DEVELOPMENT DETERMINATION PANEL MEETING

WEDNESDAY 13 MARCH 2024

ITEM 3.1	DA2023/0846 - 11 CAPRI CLOSE AVALON BEACH - SUBDIVISION OF ONE LOT INTO TWO AND CONSTRUCTION OF A NEW DWELLING HOUSE
-----------------	---

DEVELOPMENT APPLICATION ASSESSMENT REPORT

Figure 1. Extent of building envelope non-compliance on cross-section (source: Drew Heath Architects)

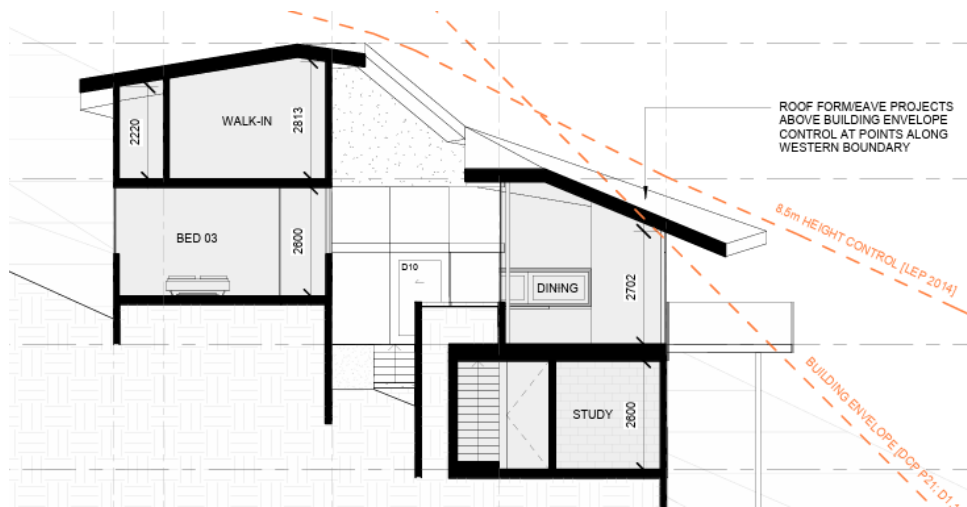
The amended proposal includes a minor breach to the building envelope. As shown in Figure 1 below, the breach is limited to the front southwestern corner of the proposed dwelling house.

The amended plans have reduced the extent of the breach by increasing the setback to the southern boundary. The encroachment is predominately the roof structure above the ground floor deck. The area of encroachment is relatively minor with the majority of the proposed dwelling house sitting comfortably within the building envelope.

Clause D1.11 allows a variation to the control "where the building footprint is situated on a slope over 16.7 degrees (ie; 30%), variation to this control will be considered on a merits basis", such is the case here.

Figure 1.

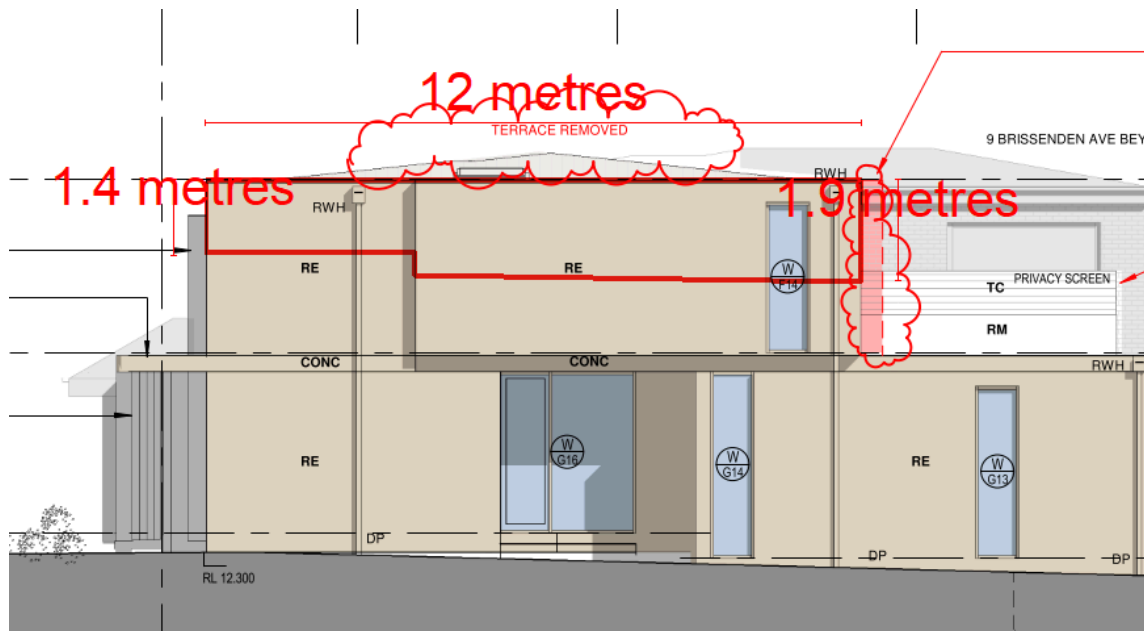
A breach of the Side Boundary Envelope control is estimated on both the east and west elevations of the proposed dwelling, as described below:

East: 12m (length) x 1.9m (maximum height) or 35% outside of the maximum permitted, see estimate depicted below. in figure 1

Figure 2.

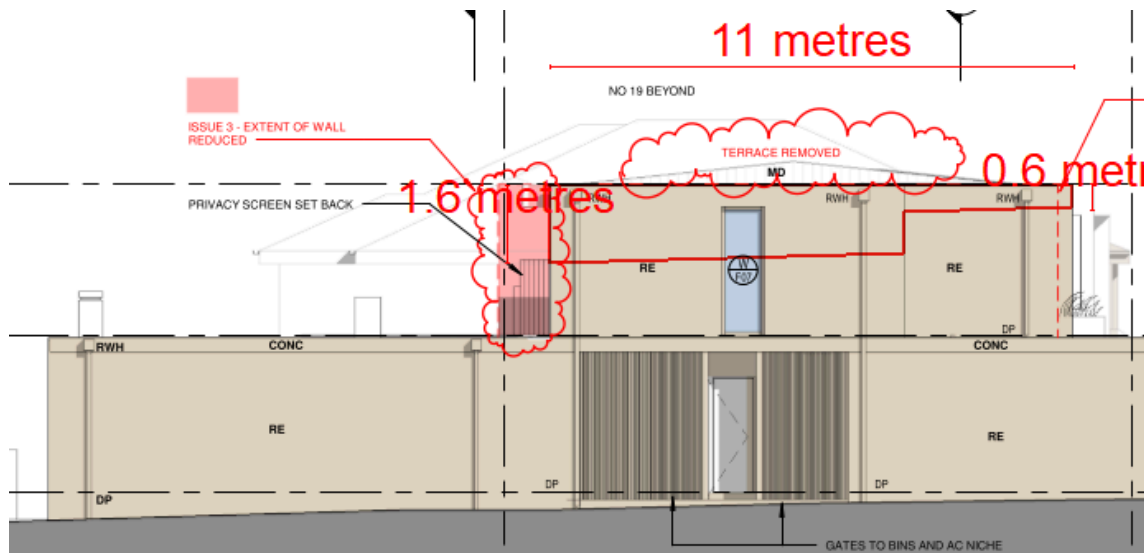
West: 11m (length) x 1.6m (maximum height) or 33% outside of the maximum permitted, see estimate depicted below in Figure 2:

Figure 1: which clearly notates "Retain access"

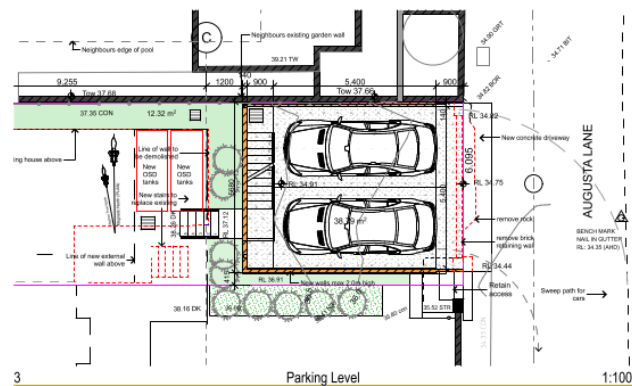
Concerns were raised about the rear entryway leading to Augusta Lane.

Comment: The plans clearly show that these stairs will be retained as part of the proposed development (see figure 1) below.

Figure 2: Section taken of the alterations and additions showing the building height non compliance

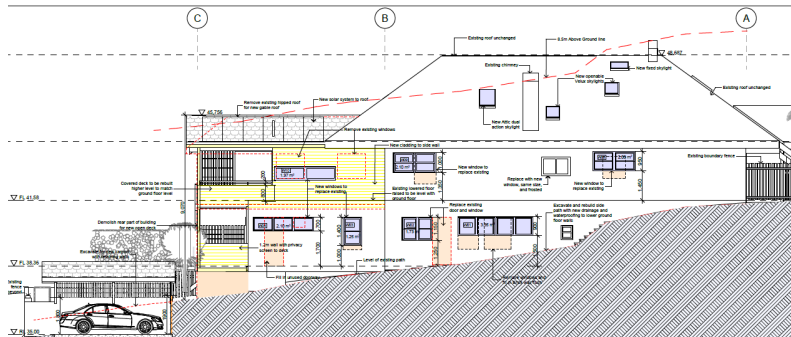
It is considered that the breach of the height of buildings control is a result of the existing excavation on site and is limited to the alterations and additions within the existing building envelope and footprint. Council agrees with the applicants argument and supports the stepping of the dwelling with the topography of the site. In addition, the proposed new roof will sit well below the existing ridge of the main roof over the dwelling and the roofs at 26 and 30 Ocean Road respectively. It is considered the proposed rear roof is consistent with the existing and desired future streetscape character and is consistent with the objectives of the control.

Figure 3: Eastern elevation taken of the alterations and additions showing the building height non compliance

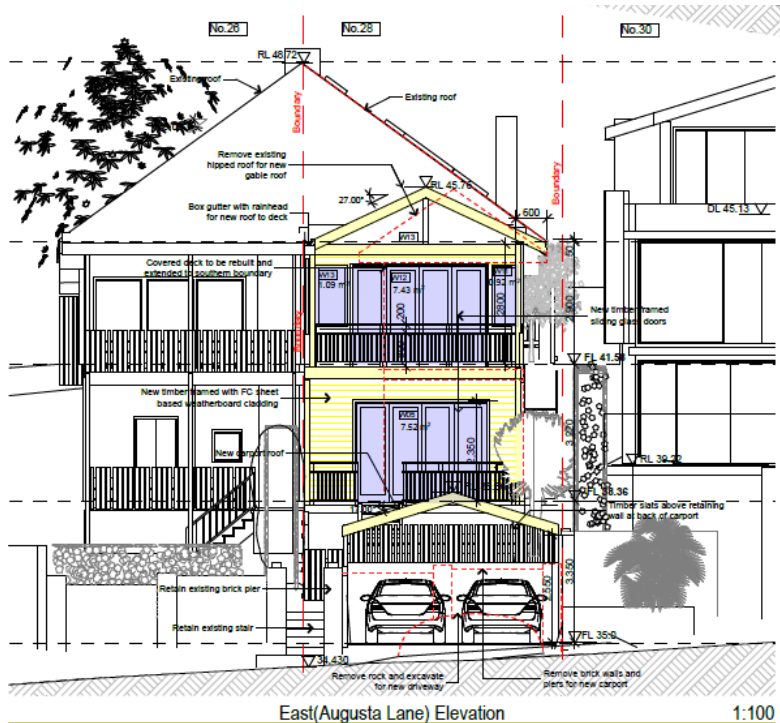
The breach occurs as a result of the alterations and additions to the existing dwelling. The breach occurs to the top of the new pitched roof over the ground floor deck. The proposed roof height is substantially lower than the existing roof on the subject site and the roofs at 26 and 30 Ocean Road respectively (see Figure 2 below). Therefore, the proposed rear roof is consistent with the existing and desired future streetscape character which reflects its appropriateness within the locality.

Figure 15: proposed deck extension with fire rated wall and aluminum privacy screen (conditioned to be deleted)

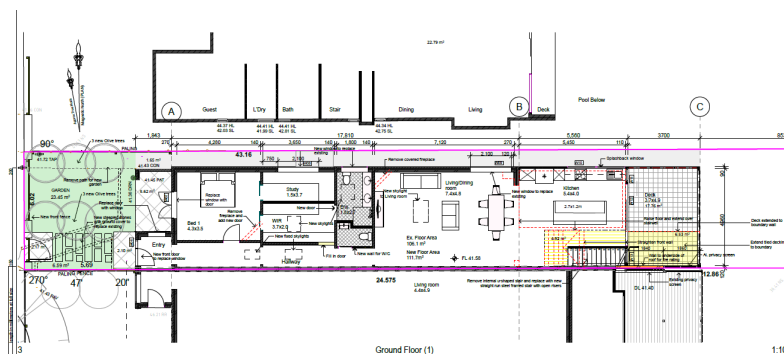
Given the above, it is deemed that the development is acceptable and demonstrates a generally consistency with the existing deck and screening at 26 Ocean Road. However, a condition will be included to remove the proposed aluminum privacy screen on the southern elevation of the proposed deck at the eastern end at 28A Ocean Road. This will preserve some views over the northern side boundary and, given the fixed nature of the privacy screen on the eastern portion at 26 Ocean Road, will help ensure that a satisfactory level of amenity is maintained between 26 and 28A Ocean Road.

Figure 1 - Extract of Section A-A (Drawing No. 2-2 1008 22, Issue 3, dated 6 February 2024) depicting building height.

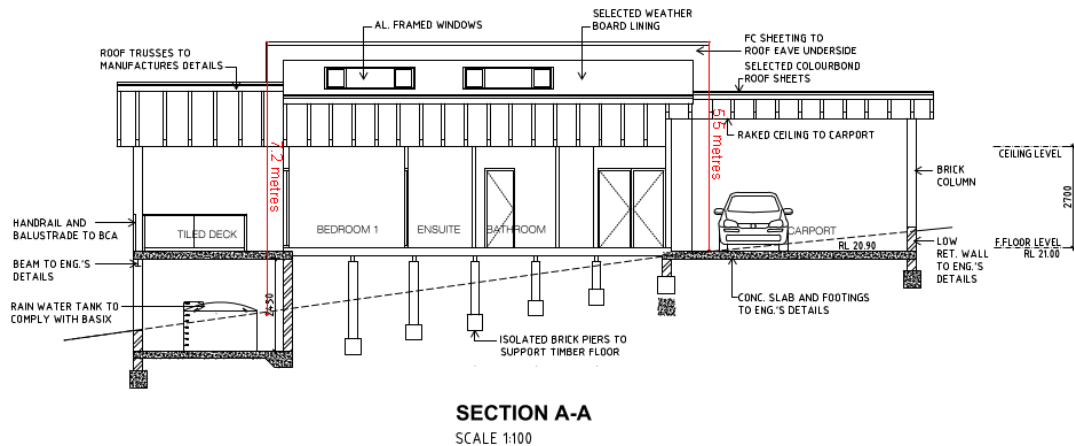
Development standard:	Height of buildings
Requirement:	5.5m
Proposed:	7.2m
Percentage variation to requirement:	30.9%

Image 1. Extent of the proposed western side boundary non-compliance, on level 2.

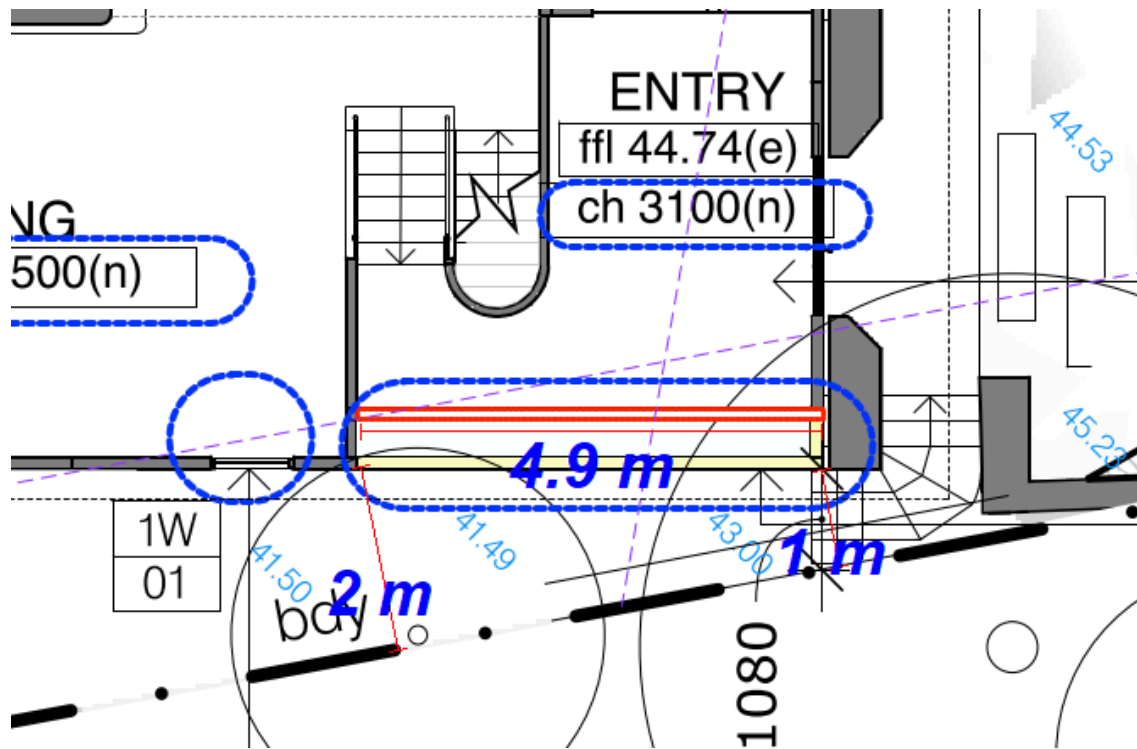
The non-compliance proposed with this application relates to the extension of the entry on level 2, depicted below in Image 1. This 4.9m long proposed wall varies in separation from the western side boundary from 1m to 2m for its length. Additionally, this modification proposal is compliant with the eastern side boundary and the rear boundary.

Image 2. Visualization of East Elevation boundary non-compliance

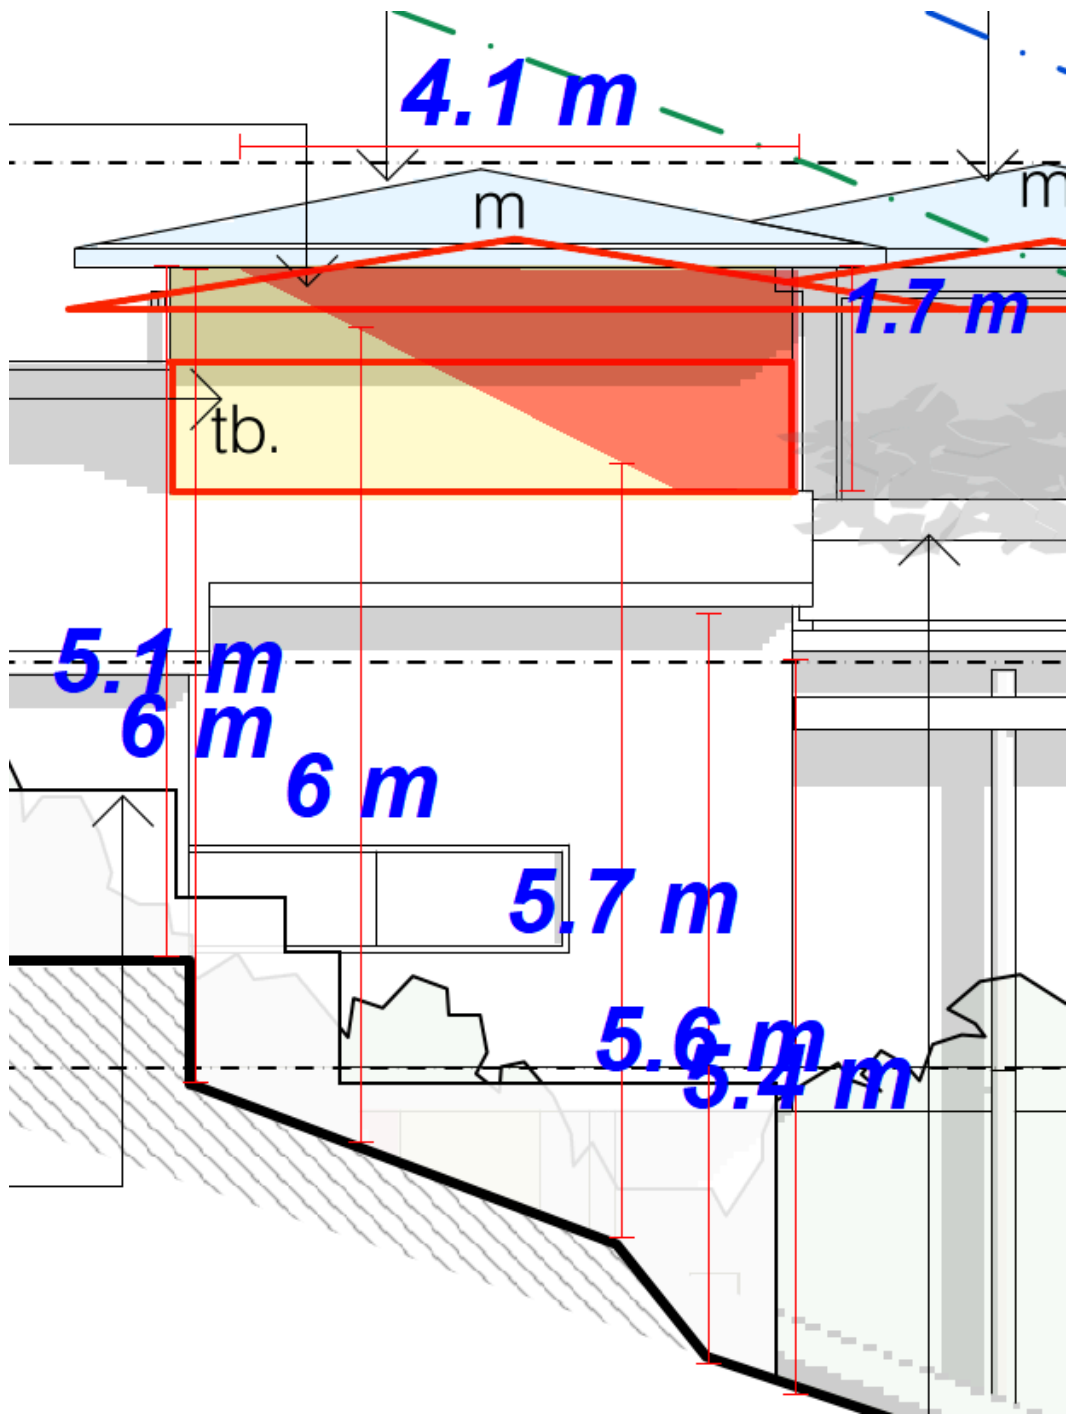
This proposal presents a variation to the building envelope non-compliance along the East Elevation, for a length of 4.1m and height from nil to 1.7m, as Image 2 below shows. This proposed non-compliance is the result of the Level 3 study extending to the east to better accommodate the internal lift. The West elevation has no increase in envelope non-compliance for this assessment, and the Level 3 alteration will reduce the extent of the non-compliance from previously approved in DA2022/1951.
